**Allyn D. Rifkin, PE**  
**Rifkin Transportation Planning Group**

**Traffic and Circulation Issues – Regarding the proposed Mount Saint Mary’s University Expansion**

**EXHIBIT 2****INITIAL STUDY  
TRAFFIC ANALYSIS**

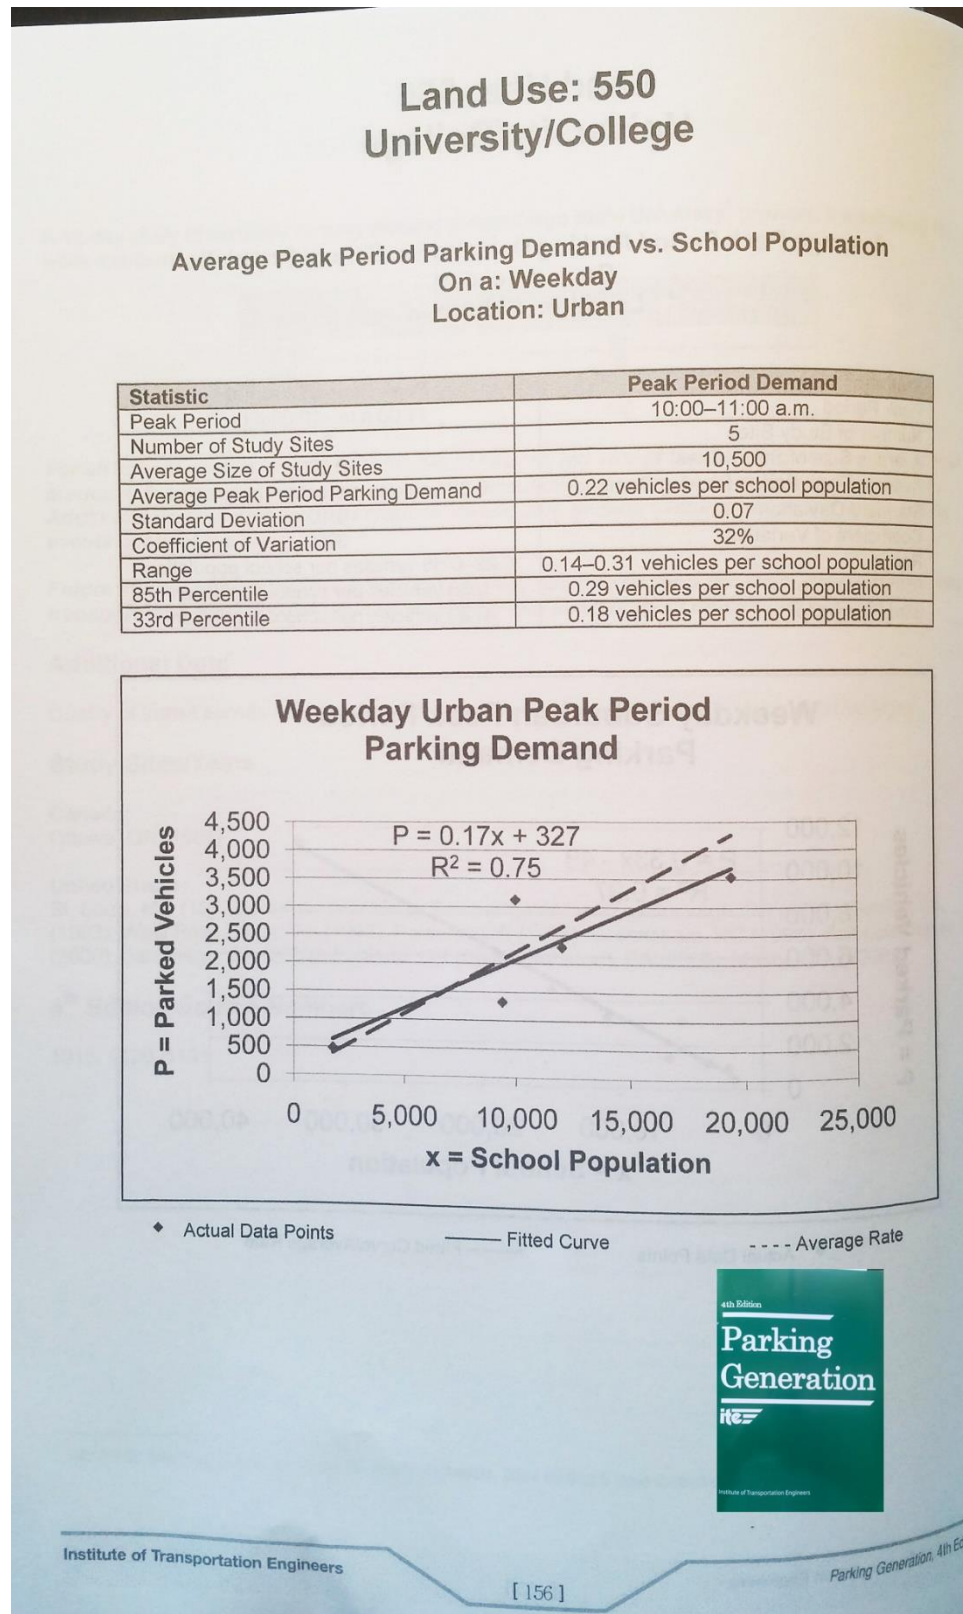
As mentioned above, I was Transportation Planning Bureau Chief at LADOT in 1984, when the Initial Study Traffic Analysis document (**EXHIBIT 2**) was signed by LADOT Traffic Engineer Charles King, and, at that time, I was his immediate supervisor. With direct knowledge of procedures in place at LADOT, I am especially qualified to interpret the findings of the Initial Traffic Study Analysis and the associated approval for the parking structure.

In an effort to evaluate the background for MSMU's current operational conditions, I have reviewed a number of historical documents that have been submitted to or issued by the City in reference to past entitlements and the current application for expansion (ENV-2016-2319-EIR). The Initial Study Traffic Analysis report by LADOT from March 28, 1984, was issued in response to an application to build a 244-space parking structure on top of an existing parking lot (EIR Case No: 113-84-CUZ). The important note on that document is that LADOT, pursuant to CEQA, did not require a traffic analysis of the requested permit and recommended a finding of **NOT SIGNIFICANT** impact for traffic "**Provided that no enrollment increase is allowed.**" During that time, MSMU's enrollment was approximately 750 students (see the January 1984 CUP for the Faculty Residence Building). From the project description it is clear that the request was to build a parking structure and not for an enrollment increase. That is how the City should have processed the entitlement. If the City instead permitted an increase of enrollment to 1,072 students (a 43% increase without additional traffic analysis and new environmental review), that would be a critical error.

Contrary to what MSMU asserts, LADOT issued the "NOT SIGNIFICANT" traffic impact determination for the July 1984 CUP with the condition that enrollment would not increase. If the permit was to provide for increased student enrollment, LADOT would have required further assessment of the added vehicle trips to determine the need for a traffic study and ultimate assessment of traffic impacts.

## EXHIBIT 6 - CIRCULATION ELEMENT for BRENTWOOD/PACIFIC PALISADES COMMUNITY PLAN

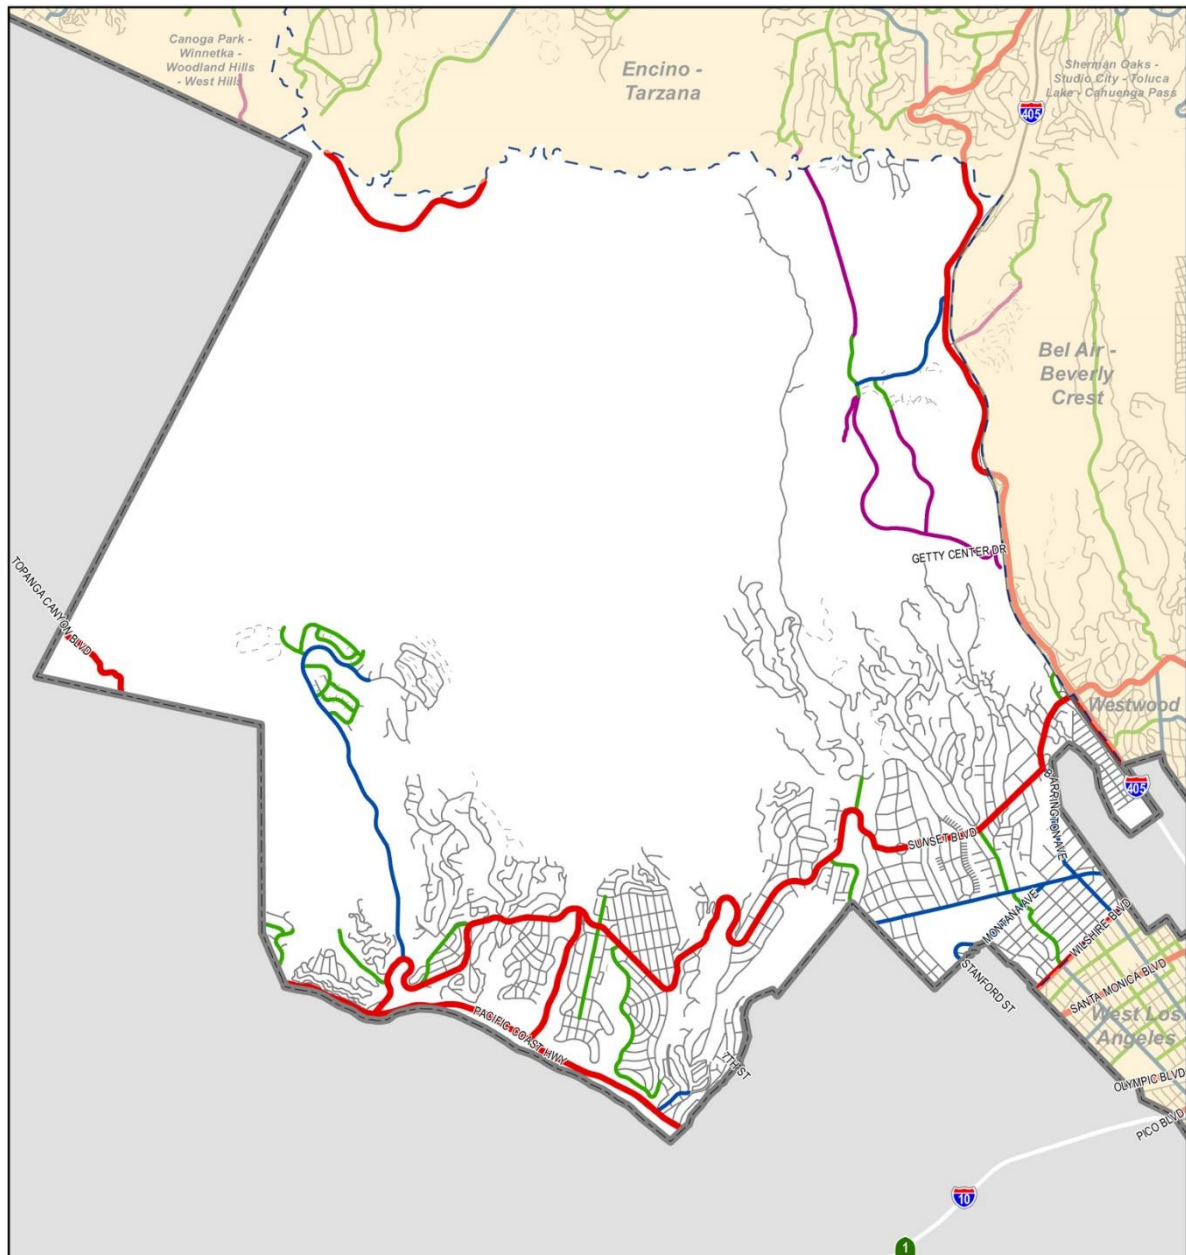
**EXHIBIT 5** shows the route to the campus from the Sunset Boulevard Corridor, namely Bundy Drive, Norman Place and Chalon Road. According to the Circulation maps from the latest adopted Brentwood-Pacific Palisades Community Plan and the Circulation Element of the Citywide Plan, all roads to the MSMU campus are designated as “local” roads (see **EXHIBIT 6**). This appears to be in conflict with more recently adopted designations from the Baseline Hillside Ordinances (Ordinance No. 181,624 and Ordinance # 168,159), wherein these roads are designated as “Hillside Limited Streets.” In both of these criteria, the intention of these roads is that they **“are intended to accommodate lower volumes of vehicle traffic.”**
